**SECTION 16 APPLICATION
TOWN PLANNING ORDINANCE (CHAPTER 131)**

**PROPOSED SOCIAL WELFARE FACILITY (RESIDENTIAL CARE HOME FOR THE ELDERLY) IN
“VILLAGE TYPE DEVELOPMENT” ZONE ON APPROVED NAM SANG WAI OUTLINE ZONING
PLAN NO. S/YL-NSW/10 AT LOTS 3670 RP (PART), 3671 RP (PART), 3672 RP (PART) AND 3673
RP (PART) IN D.D.104, NAM SANG WAI, YUEN LONG**

Town Planning Application No. A/YL-NSW/349 - Submission of Further Information (2)

PROPOSED SOCIAL WELFARE FACILITY (RESIDENTIAL CARE HOME FOR THE ELDERLY) IN “VILLAGE TYPE DEVELOPMENT” ZONE ON APPROVED NAM SANG WAI OUTLINE ZONING PLAN NO. S/YL-NSW/10 AT LOTS 3670 RP (PART), 3671 RP (PART), 3672 RP (PART) AND 3673 RP (PART) IN D.D.104, NAM SANG WAI, YUEN LONG
(Planning Application No. A/YL-NSW/349)
Response-to-Comment Table

Figure No. 4.1 Revision B

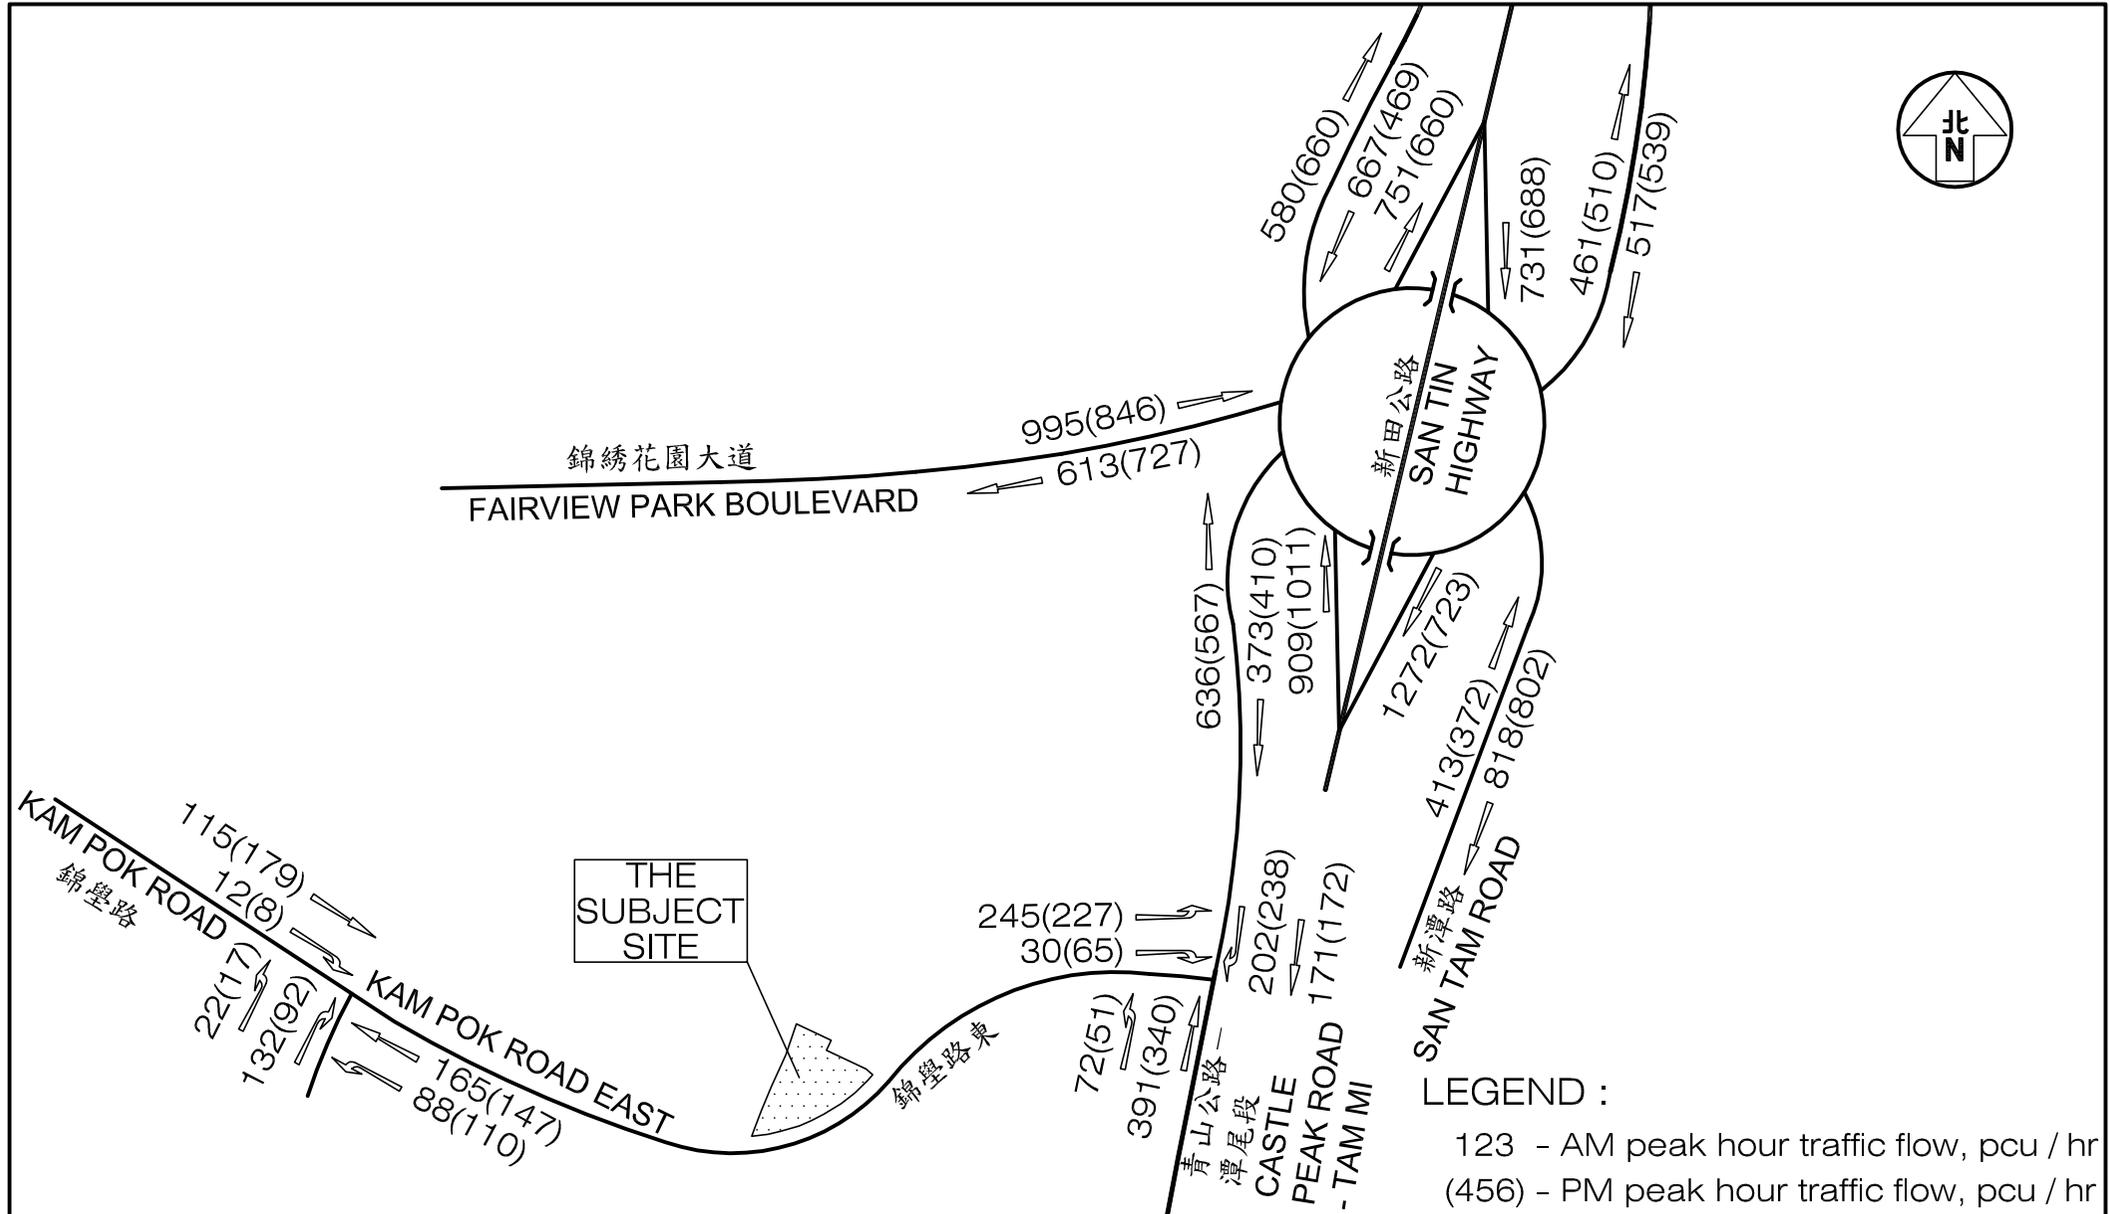
<ul style="list-style-type: none"> - Please provide a plan showing the vehicular ingress and egress routing to the subject site. Entrance for pedestrian should be shown on plan as well; 	<p>Noted. Please refer to Figure 4.1 in the revised TIA (Appendix 2) for the vehicular route and Figure 3.1 in the revised TIA (Appendix 2) for the pedestrian entrance.</p>
<ul style="list-style-type: none"> - Please provide a plan showing the pedestrian routing to the nearby franchised bus stop (both Yuen Long and Sheung Shui bound). Please specify the corresponding walking distance as well; 	<p>Noted. Please refer to Figure 2.7 in the revised TIA (Appendix 2) for the pedestrian route to the nearby franchised bus stops.</p>
<ul style="list-style-type: none"> - Para. 4.8: traffic trips specified here does not tally with the number in Table 4.4; 	<p>Noted. Please refer to section 4.8 in revised TIA (Appendix 2)</p>
